ECE/TRANS/WP.29/2010/9
18 December 2009

World Forum for Harmonization of Vehicle Regulations

Proposal for Supplement 17 to the 02 series of amendments to
Regulation No. 7
(Front and rear position side lamps)

Submitted by the Working Party on Lighting and Light-Signalling */

"FRONT AND REAR POSITION LAMPS, END-OUTLINE MARKER LAMPS AND STOP-LAMPS: MINIMUM ANGLES REQUIRED FOR LIGHT DISTRIBUTION IN SPACE OF THESE LAMPS 1/

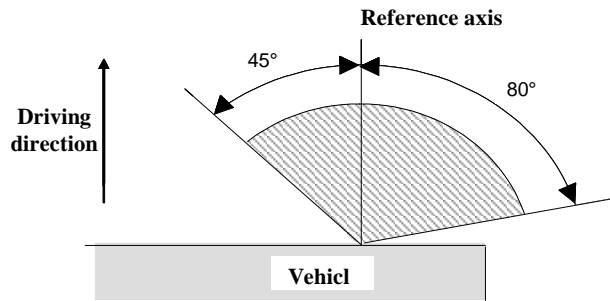
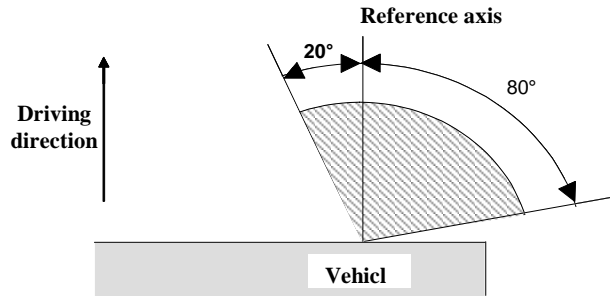
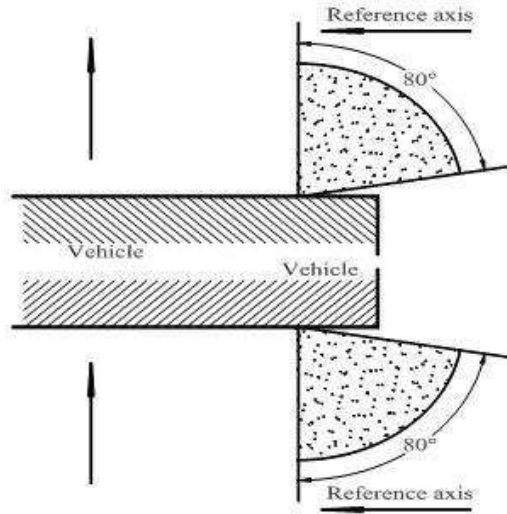
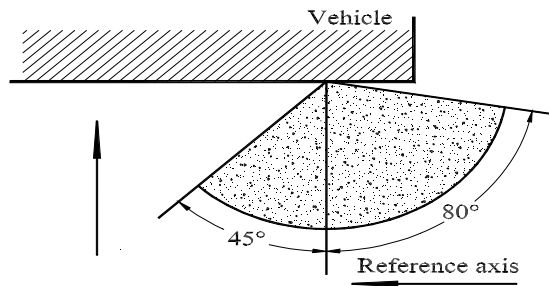
Annex 1, amend to read:

In all cases,

- ...
- (b) for category S3 or S4 stop lamp for which they are 10° above and 5° below the horizontal;

1/ The angles shown in these diagrams are correct for devices to be mounted on the right side of the vehicle. The arrows point to the front of the vehicle.
